DEVIATION REQUEST AND DECISION FORM

Project Name :	Falcon Reserve
Schedule No.(s) :	5225400001
Legal Description :	See Attached

**FALCON RESERVE
PRELIMINARY PLAN**

DEVIATION EXHIBIT

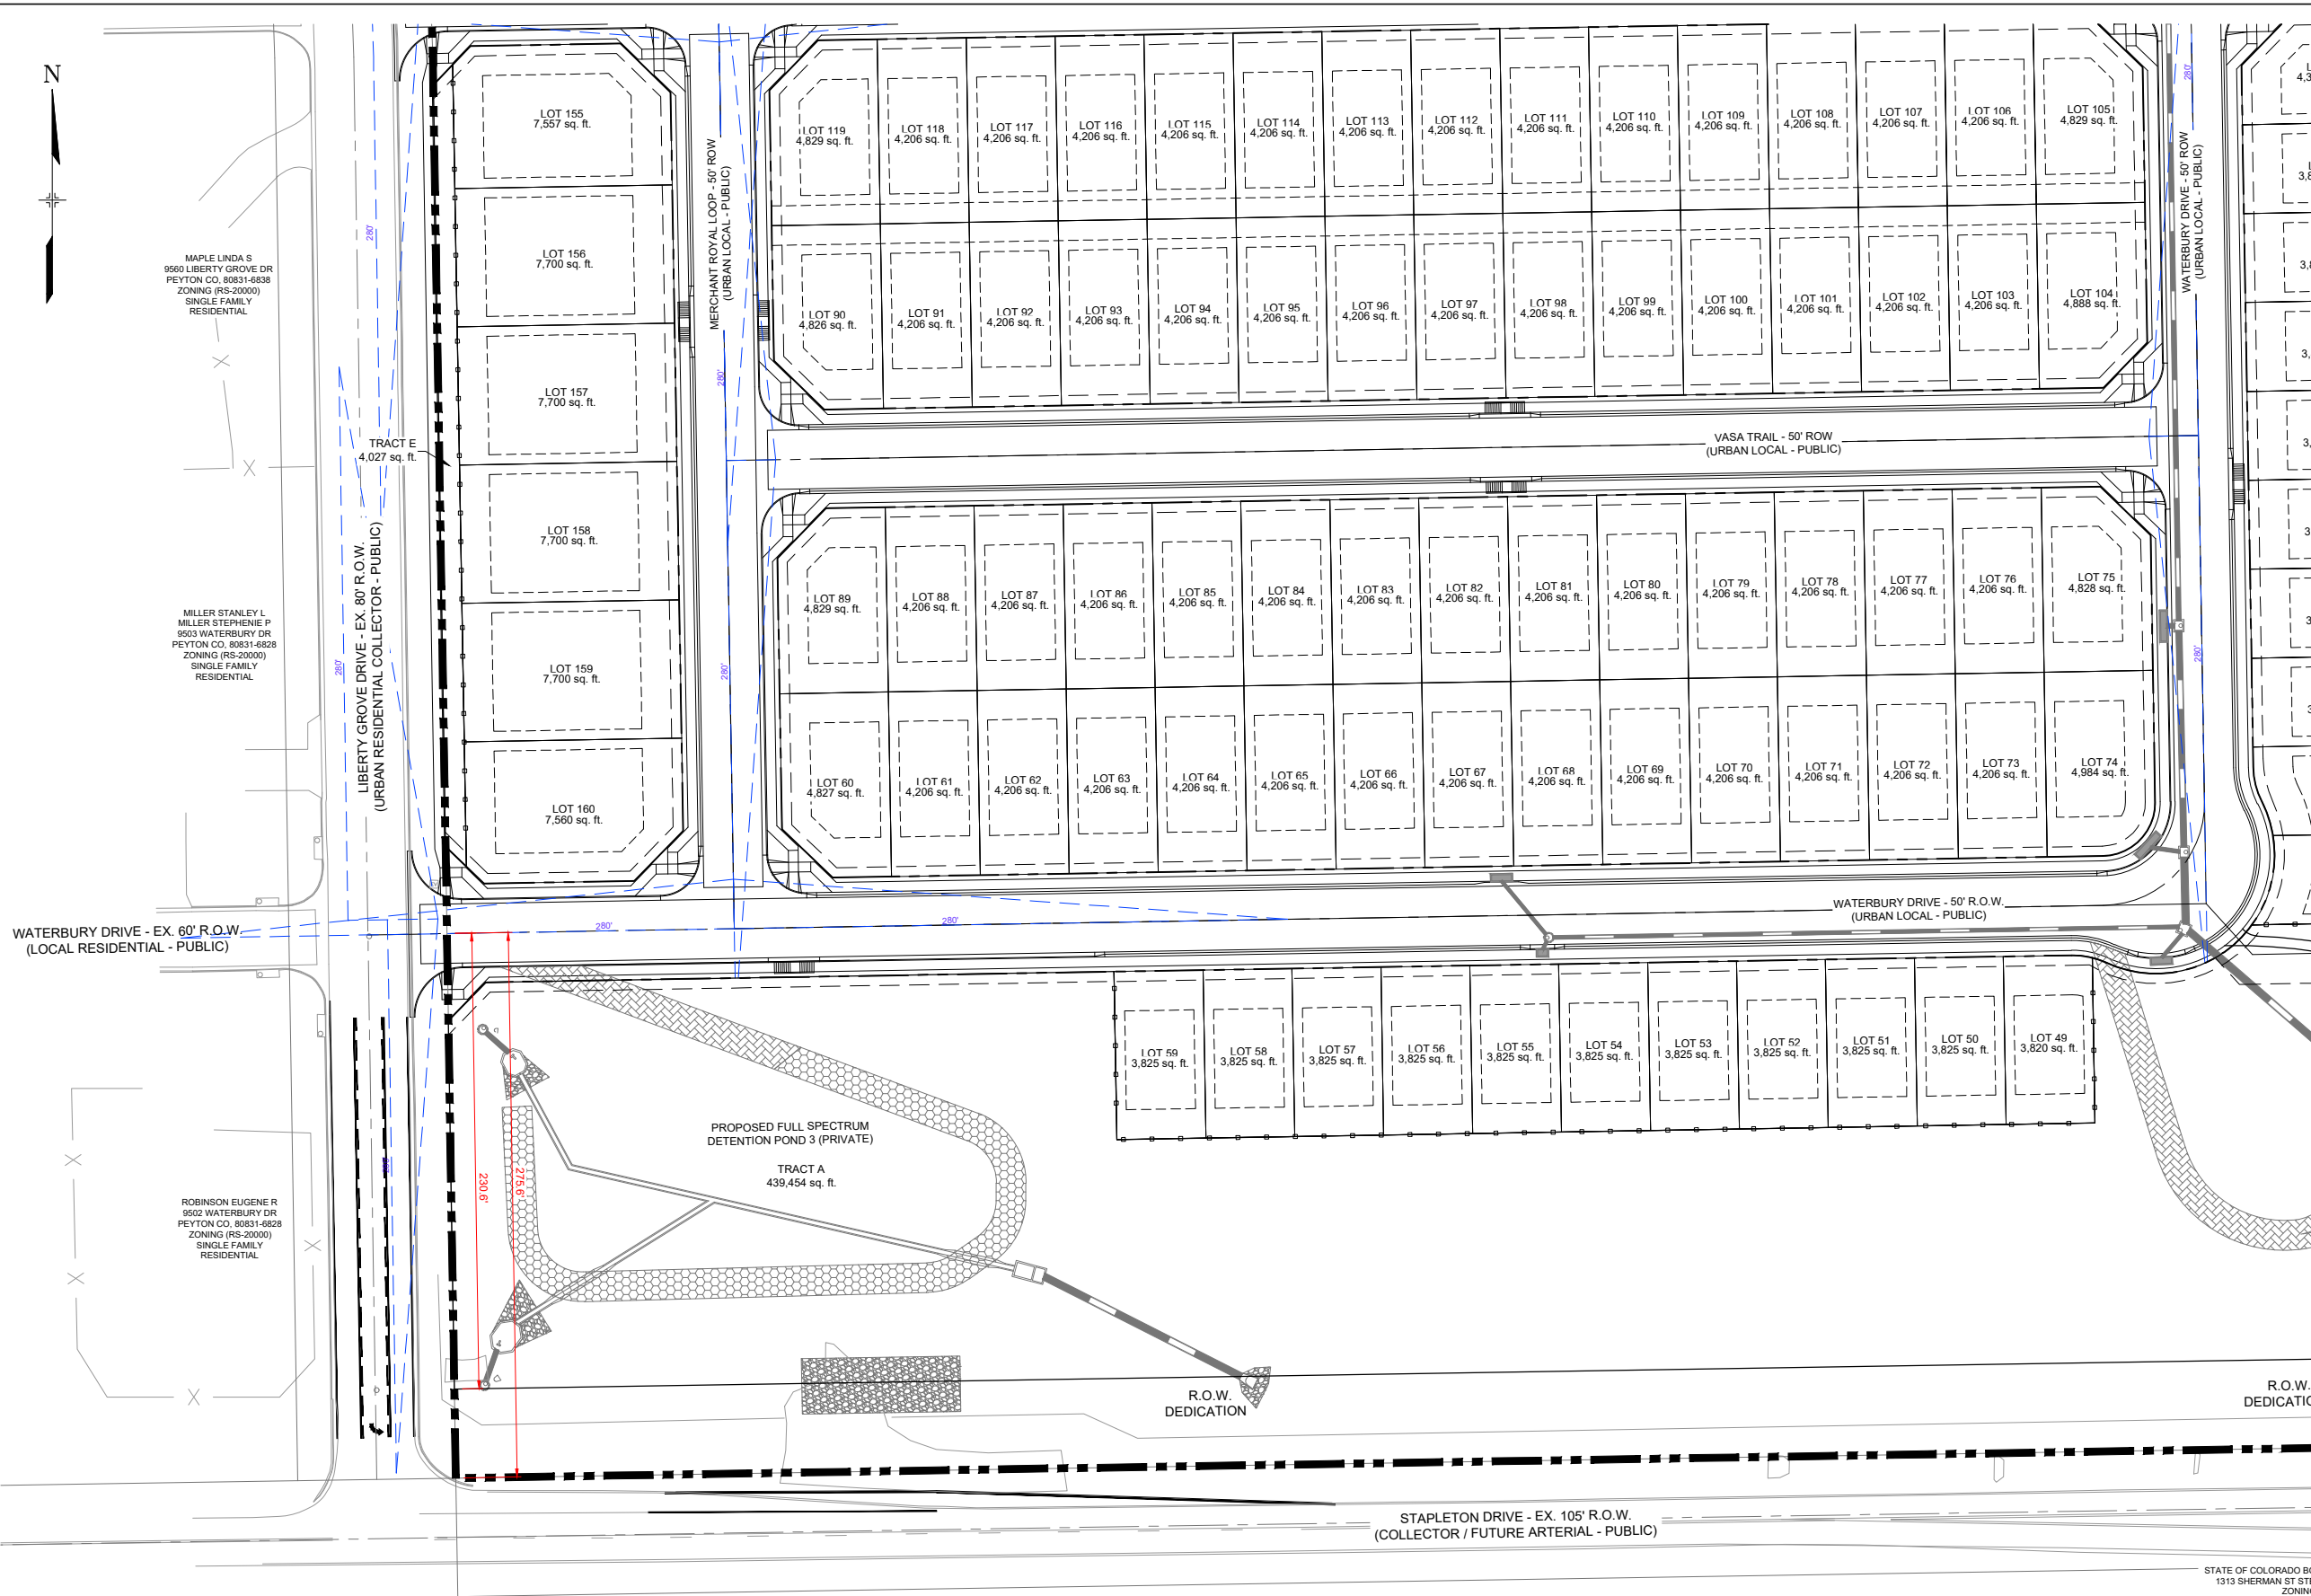
Roadway Access Criteria: On minor collector roadways, the closest local roadway intersection to an arterial roadway shall be 330 feet (right-of-way line of arterial to centerline of local roadway).

To permit a proposed urban local roadway and an existing collector roadway to intersect ROW to centerline closer than 330' at the intersection of Liberty Grove Drive and Stapleton Drive. The proposed urban local roadway will line up with existing Waterbury Drive and is approximately 275' from centerline to the existing ROW of Stapleton Drive or 230' to the future ROW.

The proposed alternative to the ECM standard is requested because the required roadway spacing of 330' is not achievable while still maintaining the logical extension of existing Waterbury Drive.

The 330' intersection spacing requirement is not achievable while still maintaining the logical extension of existing Waterbury Drive. Proposed Waterbury Drive, the intersecting road, is proposed as an urban local roadway. The existing intersection of Waterbury Drive and Liberty Grove Drive currently exists at less than the required 330' spacing, approximately 230'.

The modification to permit roadway intersections less than 330' will not adversely affect safety or operations as this intersection is not designed as a through street, limiting traffic to mostly residents. Given the limited traffic and cut through options, the shortened intersection spacing is not expected to cause any queuing constraints. In addition, pedestrian safety will not be compromised by the shortened intersection spacing.

This request has been determined to have met the criteria for approval. A deviation from Section 2.2.5 (D) of the ECM is hereby granted based on the justification provided.
